Shop Drawing Submittal Review

Project Name: Webster University-**ISB**

Copies	No.	Description
1 PDF	224216P02	(Submittal No.'s)
		(Cannon #22 4216.16-001) - (Paric #15051-) - (WES #607)
		➤ Commercial Sinks
		• Clinical Service Sink CSS-1
		• Scrub Sink SS-1
		• Sink SK-1
		• Garbage Disposer GD-1
		• Sink SK-2
		• Sink SK-3
		• Mop Sink MS-1
		• Kitchen Sinks KS-1, KS-2, KS-3

SPEC SECTION: 22 4216.16
Commercial Sinks

PFPTB100/200/300/400 Series**Adjustable Tubular P-Traps****PFPTB101**

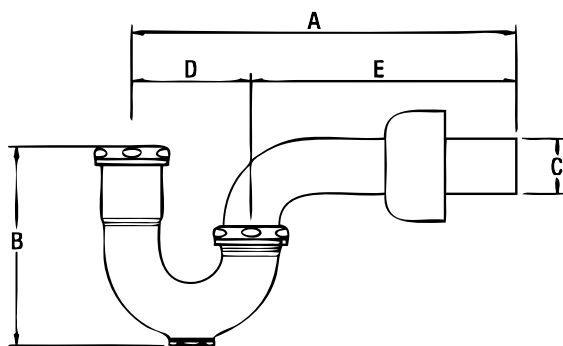
1. Provide under counter waste and supply protective piping covers as required.
Verify requirements with the architectural drawings.
2. Escutcheons are specified to be cast brass. Refer to specification section 220518.
